Access Compliance Report

Public Rights-of-Way

(Pedestrian Signals)

Intersection ID: N/A	Main Street:	Cross Street: N/A	Location: N/A
ADA ID: 14546D740525	Signal Type: Two Push Buttons-Non APS	Overall Compliance: No	Severity Score: BTN 1:N/A BTN 2: N/A No BTN: N/A
Codes/Mitigation Info/Possible Solution		Field Measurements/Component Compliance

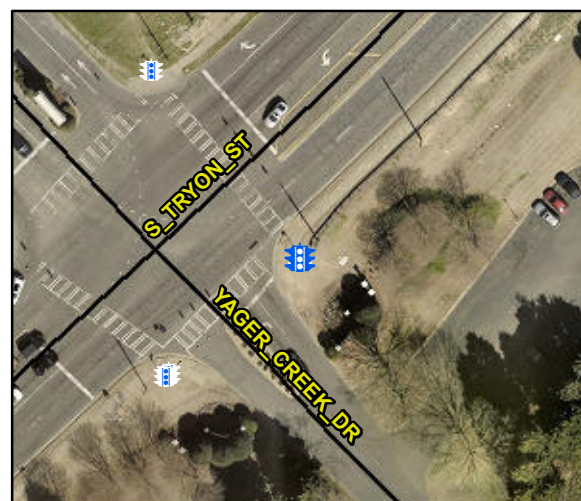
Yes	B 1 Clear Xing Direction?	ClearlyMarked	Yes	B 2 Clear Xing Direction?	ClearlyMarked
	B 1 Crossing Direction	To SW		B 2 Crossing Direction	To NW
No	B 1 DistanceTo XWalk (in)	65.0	Yes	B 2 DistanceTo XWalk (in)	0.0
No	B 1 DistanceTo Curb (in)	112.0	No	B 2 DistanceTo Curb (in)	109.0
No	B 1 Diameter (in)	1.5	Yes	B 2 Diameter (in)	1.5

Possible Solutions: Replace Signal Push Button With APS Button on New Post. Remove & Relocate Sign.

PROW/ADA: TMUTCD 4e.08, R404.2, R404.3, DMS-11132
